30-015-39111

TEXAS 32 FEE

SUNDRY NOTICES AND REPORTS ON WELLS

Texas 32 Fee #3

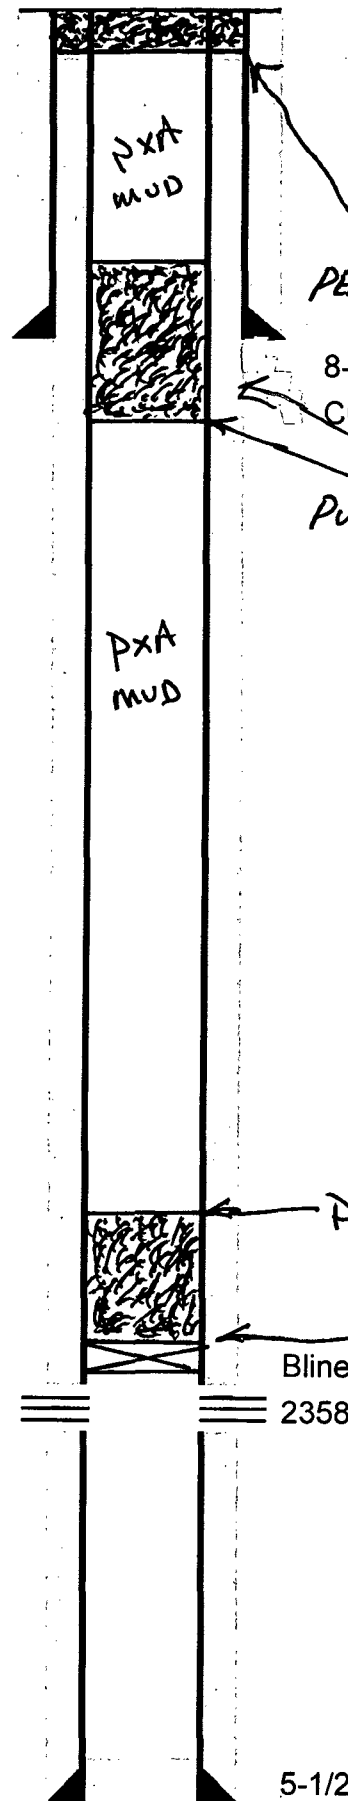
PERF. XCIRC. 25 sxs. @ 60'-3'

PERF @ 994' - SQ - WO & TAG
Pump 30 sxs. @ 994' - 810' - TAG

Pump 25 sxs. @ 2300' - 2100'

SET 5 1/2" CD3P @ 2300' WO & TAG

Texas 32 Fee #3

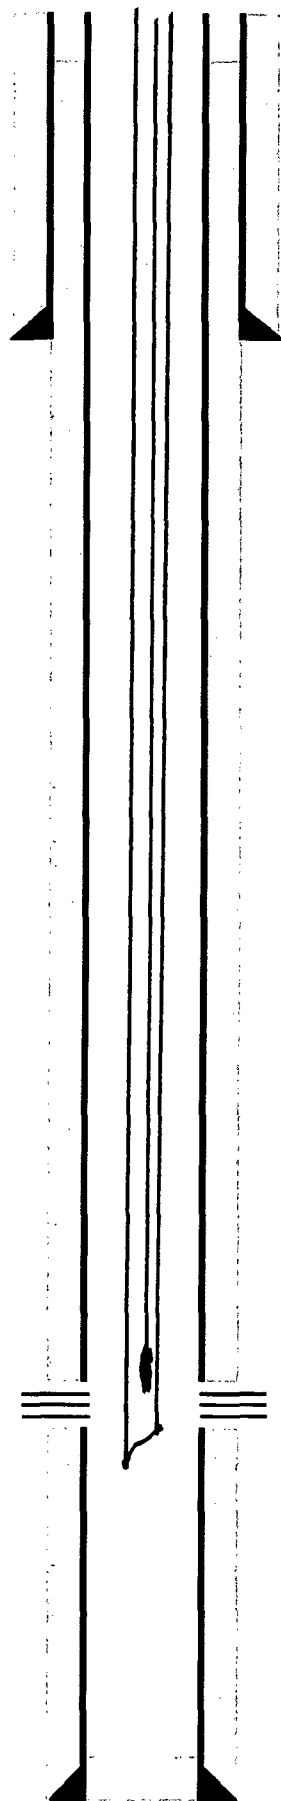
- 1) SET 5-1/2" CIBP @ 2,300'; PUMP 25 SXS. CMT. @ 2,300'-2,100' (T/GLOR.); CIRC. WELL W/ PXA FLUID. - *WIE 2 TAB*
PERF - 2) ~~PUMP~~ 30 SXS. CMT. @ 994'-810' (8-5/8" CSG. SHOE, T/S.A.); WOC X TAG CMT. PLUG.
3) PERF. X CIRC. TO SURF., FILLING ALL ANNULI, 25 SXS. CMT. @ 60'-3'.
4) DIG OUT X CUT OFF WELLHEAD 3' B.G.L.; WELD ON STEEL PLATE TO CSGS. X INSTALL DRY HOLE MARKER.

Approved for plugging of well bore only.
Liability under bond is retained pending receipt
of C-103 (Subsequent Report of Well Plugging)
which may be found at OCD Web Page under
Forms: www.oand.state.nm.us/oed.
